ITEM# 2.3

PRELIMINARY & FINAL PLAT APPROVAL:

Glamar Estates Phase II
Being 0.28 gross acre tract of land, more or less, out
of Lot 245, John H. Shary
R-1
Developer: Gladiz Marquez
Engineer: Salinas Engineering & Assoc.

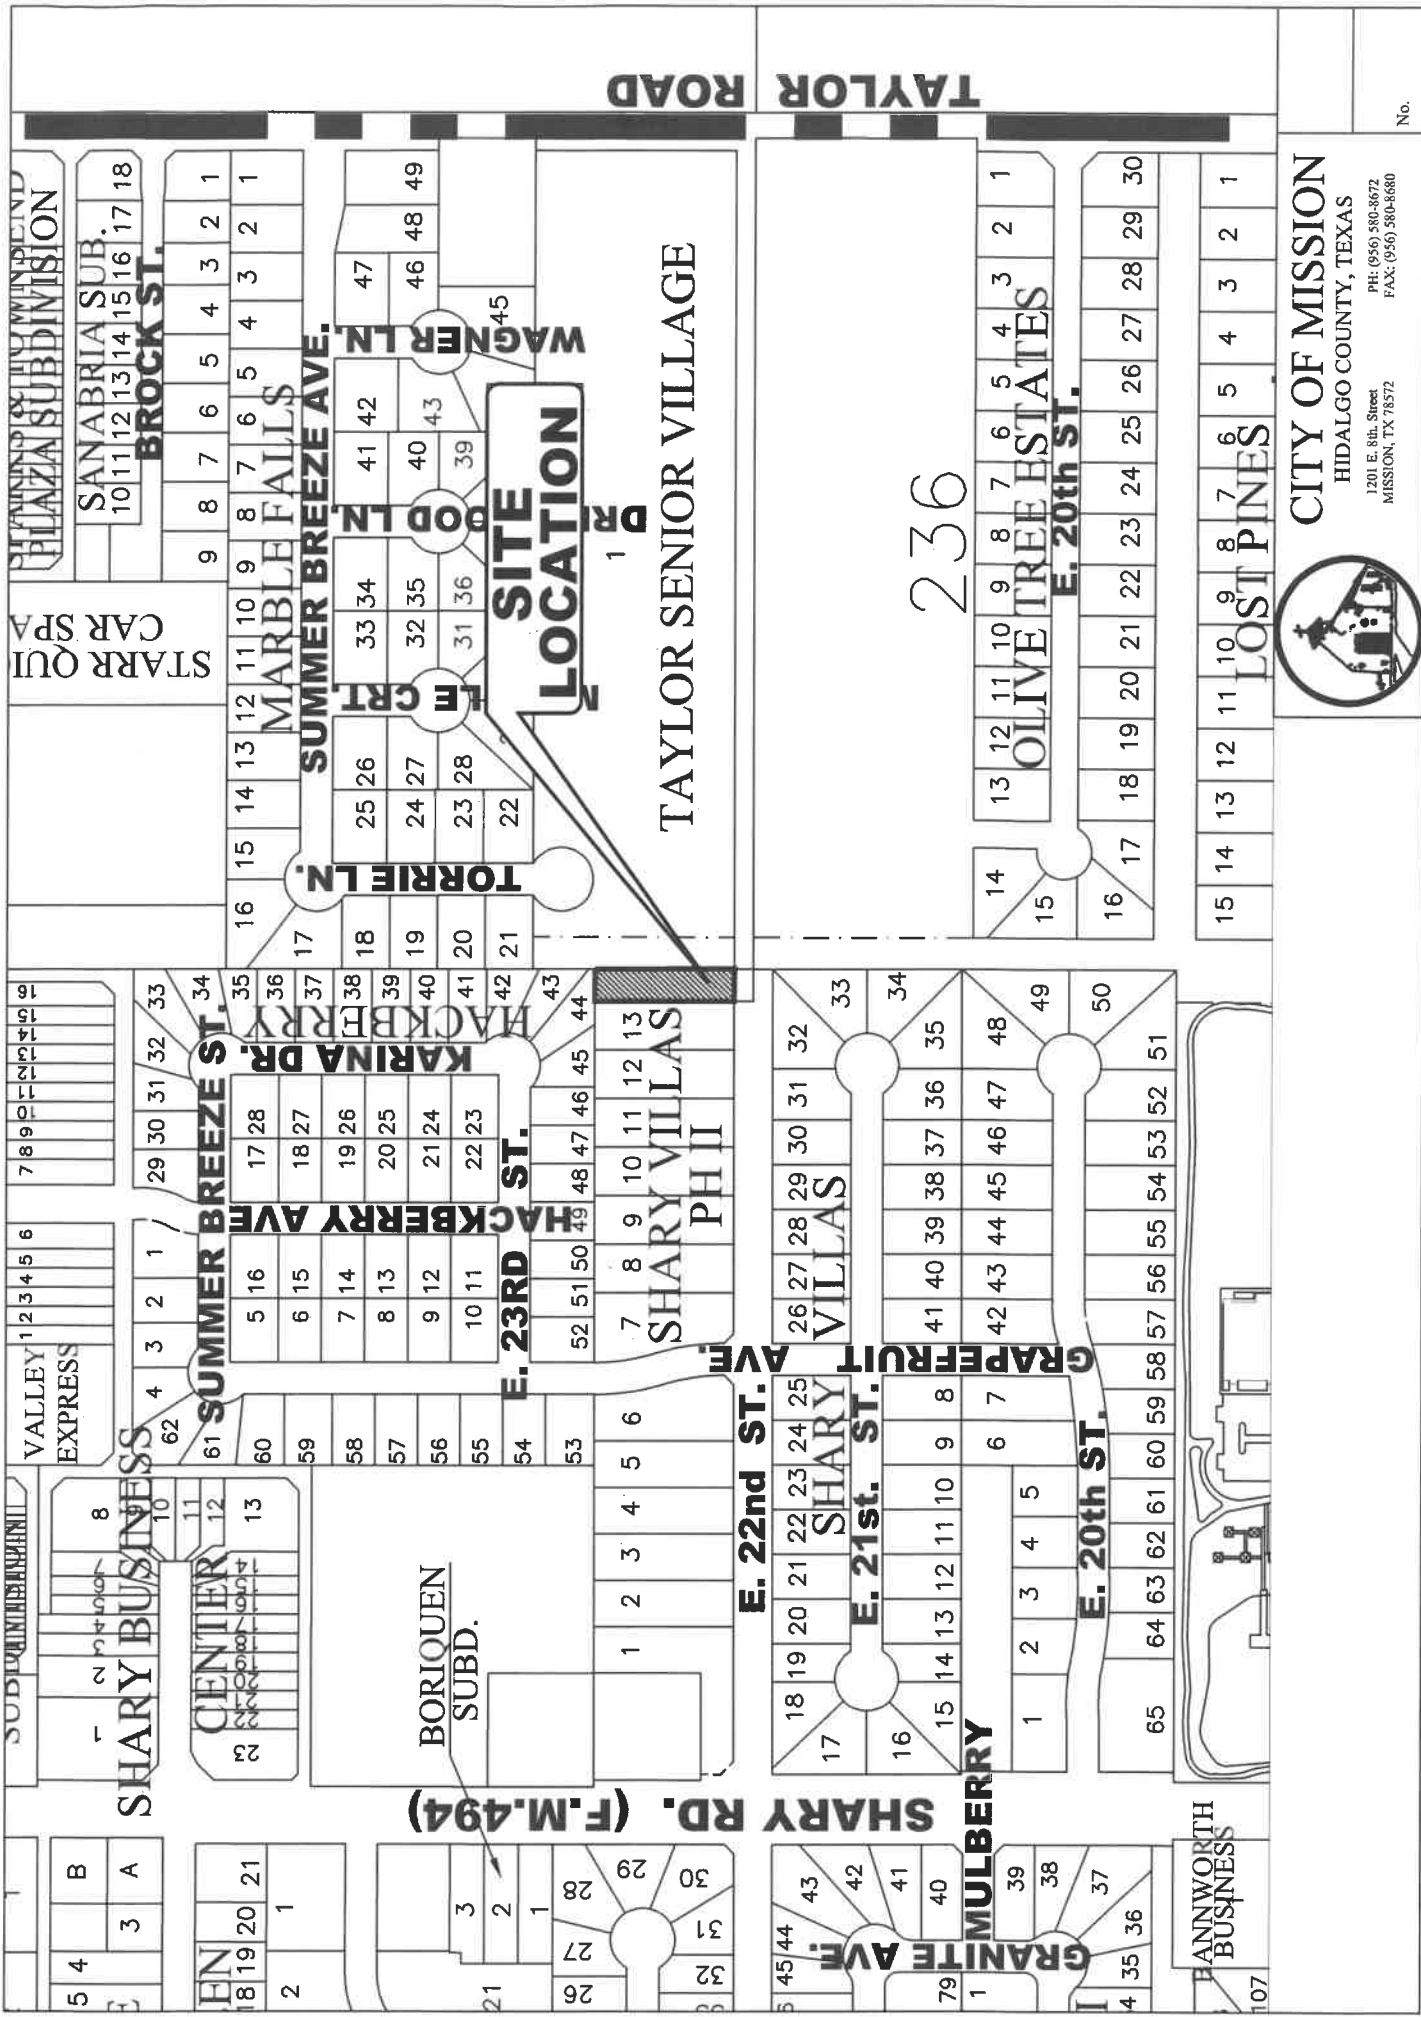
The site is located at the intersection of E. 22nd St. and future Bannworth St. - see vicinity map. Proposed Glamour Estates Ph II is a one-lot single-family residential lot. The developer is requesting a variance for the minimum lot frontage from 60' to 50', per Zoning Code, Appendix A, Area requirements. - see plat for actual dimensions, square footages, and land uses.

The developer will connect to an existing 8" water line located along the north side of E. 22nd St.
- see utility plan

The sanitary sewer line will connect to an existing 8" line along the north R.O.W of E. 22nd St.
The Capital Sewer Recovery Fee is required at \$200.00/Lot.

This lot will abut to E. 22nd St. which is a city owned and maintained curb & gutter roadway complete with storm drainage within a 32' B-B paved ROW. The site will have a minimum detention of not less than 1071.8 cuft and a max. permissible discharge of .28 cfs. Any runoff shall enter the E. 22nd St. and flow west to an outfall into the curb inlet drainage system. The City Engineer has reviewed and approved the drainage report.

Staff recommends approval subject to:

1. Payment of Capital Sewer Recovery Fee's
2. Provide Water District Exclusion, and
3. Approval of the variance
